"CCC Requested Additional Information" for Appeal to Board of Supervisors

Building floor plans, Additional Option #2 floor plan, building elevations, Wheelchair ramp

Applicant Replies to CCC Department of Community Development (DCD) Request more Information letter 7/3/2018

Design Option Proposal #2 (9-6-2018)

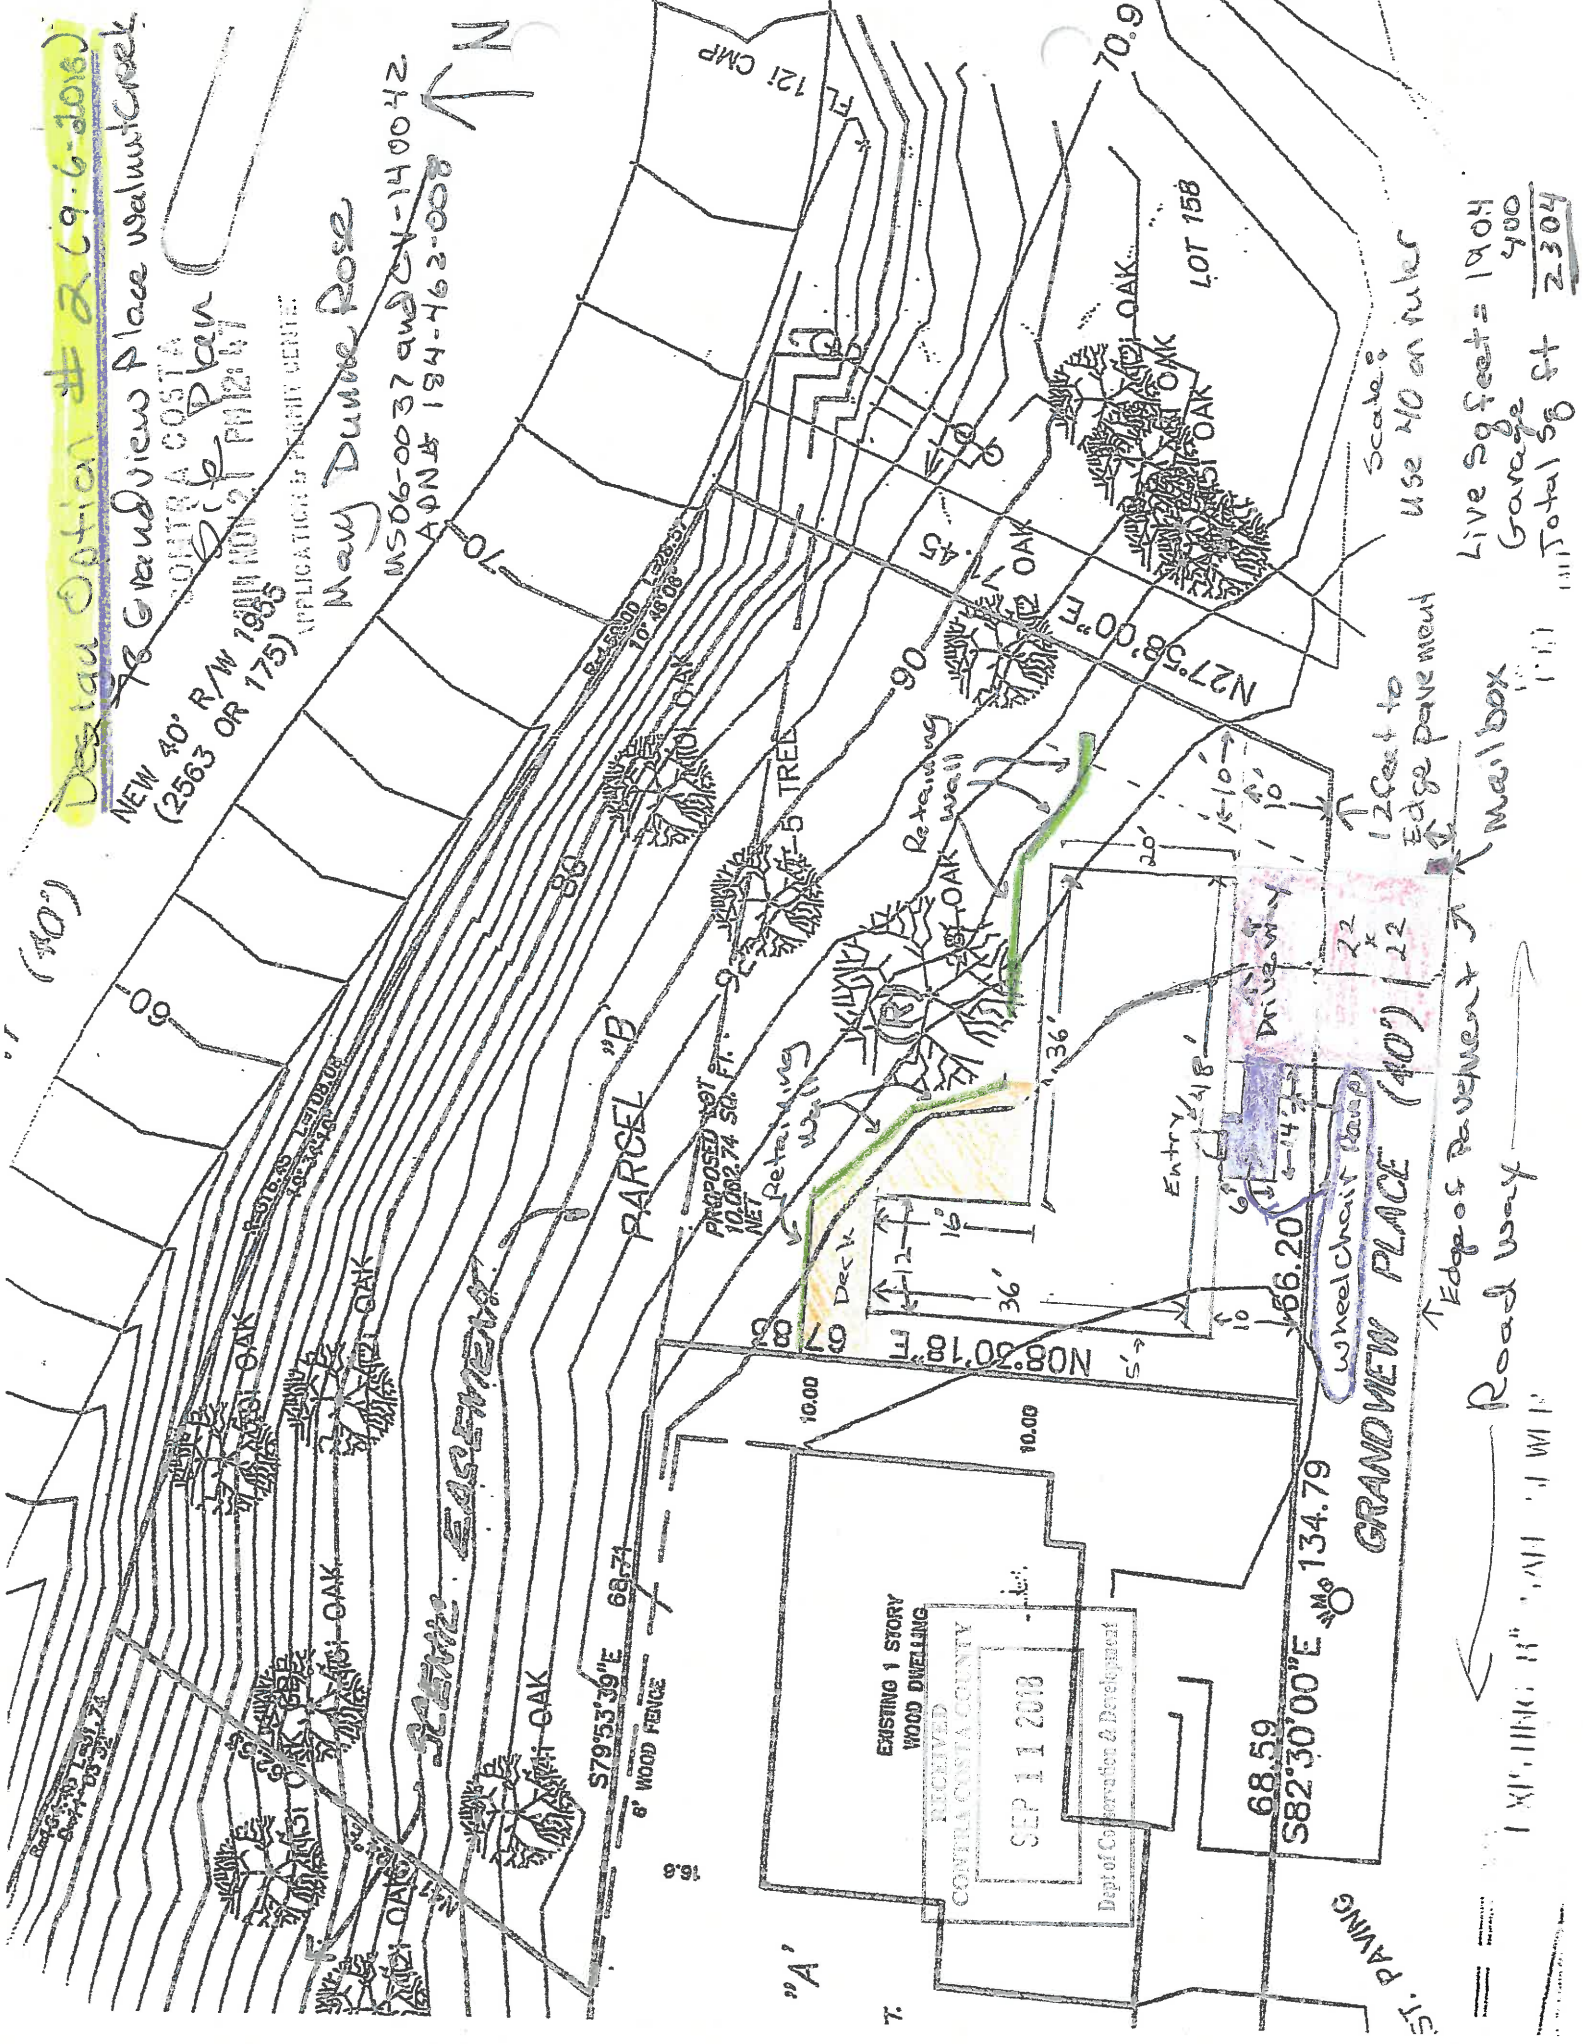
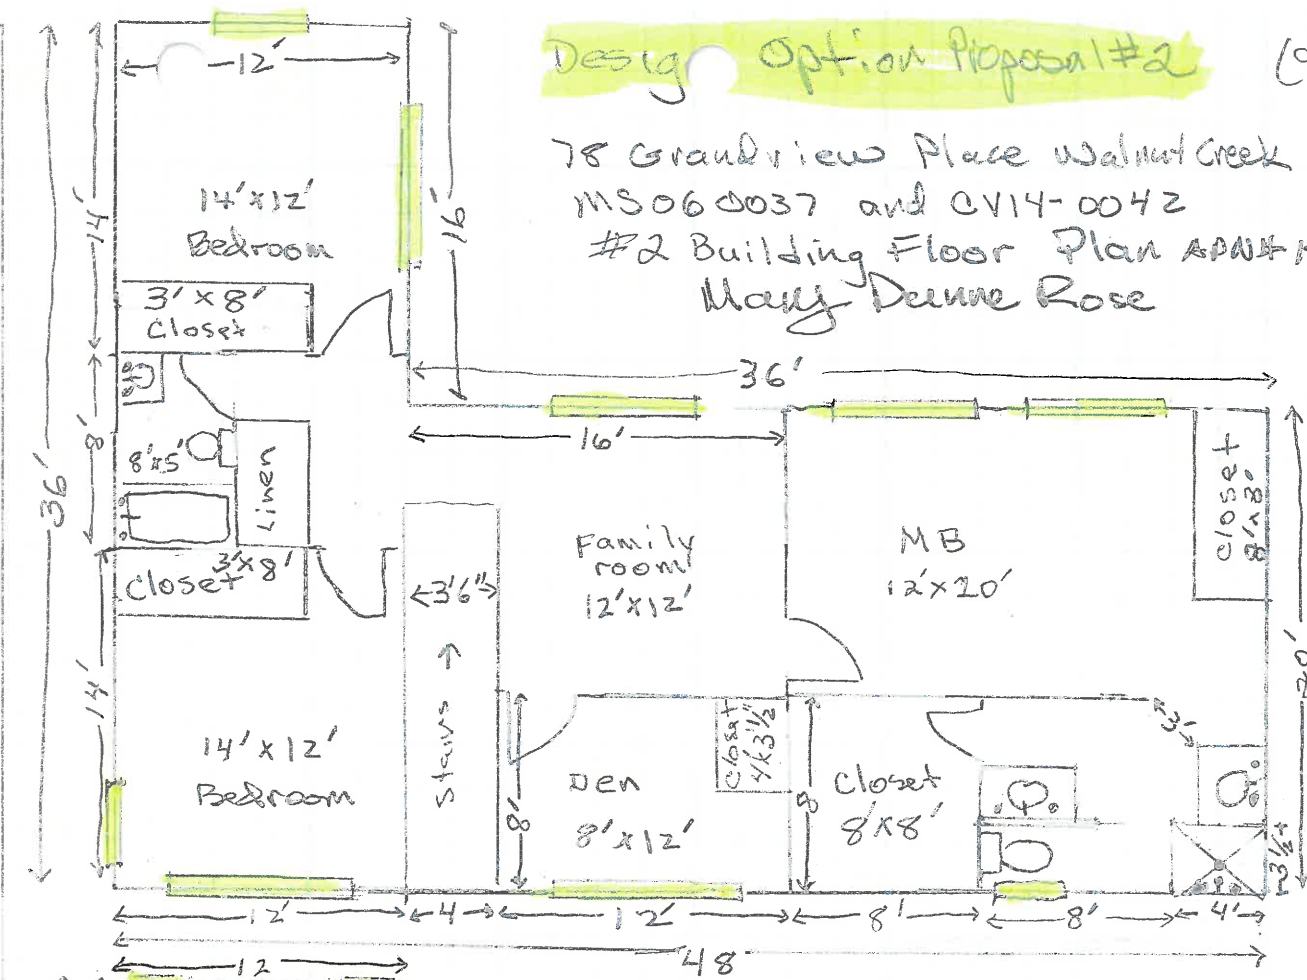
- 1.) CCC writes "Provide additional information ...such as a site plan, building floor plan or building elevation that illustrates" why CCC should not deny Reasonable Accommodation request saying "desired design elements cannot be accommodated without waiving the applicable structure setbacks..."

Applicant provided an option #2 site plan, building floor plan (2,304 sq. ft.), related elevation plan with less square footage than approved by CCC at 2,500 sq. ft. See option # 2 attached. Also attached is Original design with site plan, building floor plan (submitted already to CCC many times) and elevation plan.

Requested needed reduction in front of home setback rules that is needed will then allow the home to be built closer to the neighborhood street and applicant's mailbox to reduce barriers of walking created by my impaired mobility disability. Applicant needs the home closer to the street (reduced walking distance from home) to lessen the distance and difficulties in performing manual tasks such as walking, increasing safe, easier mobility to the mailbox and back each day to collect mail and put in outgoing mail. The same nexus connection "reduced walking distance" relationship applies to weekly taking out the garbage cans to the edge of street for pickup and proper sanitation disposal and putting these 3 separate empty cans away. Finally, applicant receives 2 newspapers daily, and needs to pick these up also. Also, important, the home built closer to the street with reduced setbacks due to RA granted reduction in governmental setback constraints, comply with RA laws and eliminating regulatory barriers, is needed to lessen the mobility difficulties caused by my particular handicap and reduce the distance from the home to walking to the street, increasing safe, easier mobility to get to the street to talk with, communicate, connect and interact with neighbors, (reducing disability caused issues such as; isolation, living like a house bound prisoner, inaccessibility and segregation of neighbors to disabled applicant), affirmatively enhancing the use of my home so as to positively impact my quality of life. This is a unique need based on mobility issues and the need to reduce isolation as applicant ages. My family will then have an equal opportunity to use and enjoy our dwelling like other similarly situated non-disabled people. See attached **site plans**, building floor plans and site plans, and building elevations plans. They show the home nearer to the Grandview Place street to allow applicant easier access to the street for above discussed reasons. See the attached site plan (both original option and option #2 with less sq. ft.) demonstrating how the home is closer to the street for easier walking to the street.

Wheel chair Ramp Plans
 78 Grandview Place
 MS060037 and CV14-0042
 Mary Dunne Rose
 APN# 184-462-008

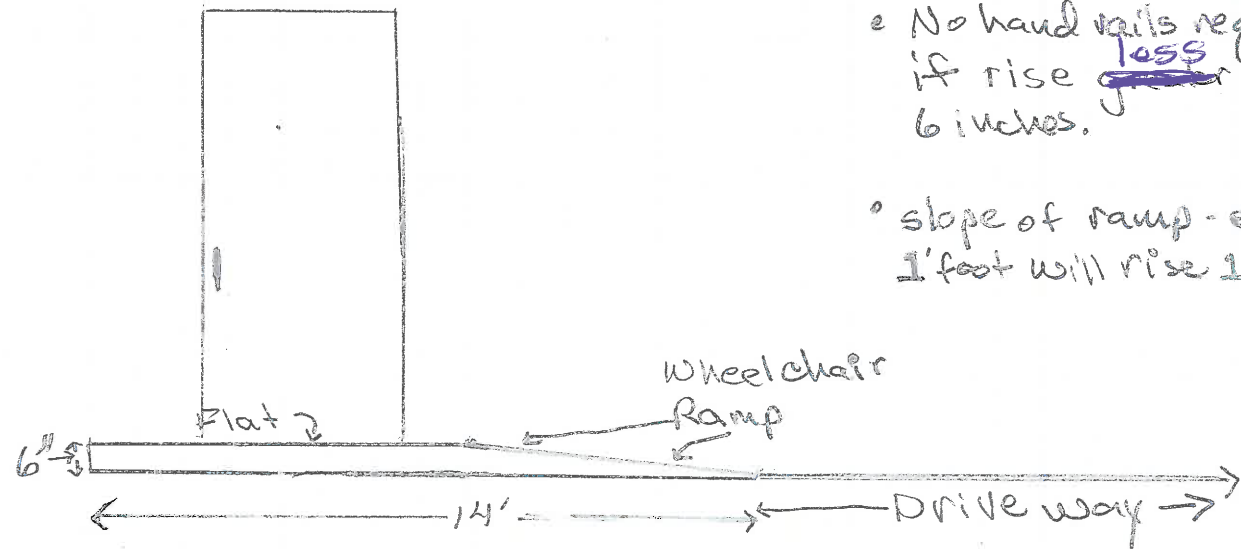
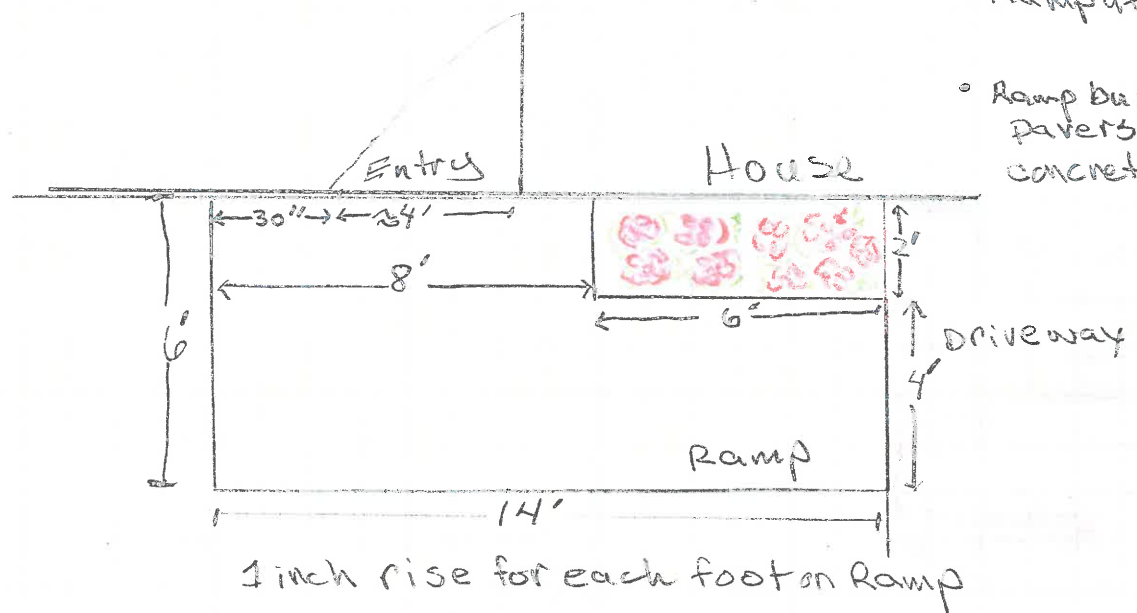
2.) *Submit "...plans indication the location and manner of construction of a wheelchair ramp at the entry of the residence and a written statement describing why the importing or exporting of fill from the site is necessary for construction of the ..." ramp.*

See attached Wheelchair Ramp Plans (now 6-inch-high total and 6-inch-high home foundation) and "revised" plans previously submitted. Height of porch-6 -inch-high porch. 6 to 7 feet in line, straight ramp up to porch. Porch size will be approximately 6 feet by 8 feet. The ramp will be 4 feet wide. The ramp will rise 1 inch for every foot of ramp. No handrails are proposed at this time as not required by law if porch height 6 inches or less. The surface of ramps shall be roughened or shall be of nonslip materials such as stamped concrete or pavers.

- No hand rails required if rise ~~less~~ ^{less} than 6 inches.
- slope of ramp - every 1' foot will rise 1 inch.

- Ramp at entry of home
- Ramp built out of pavers or stamped concrete
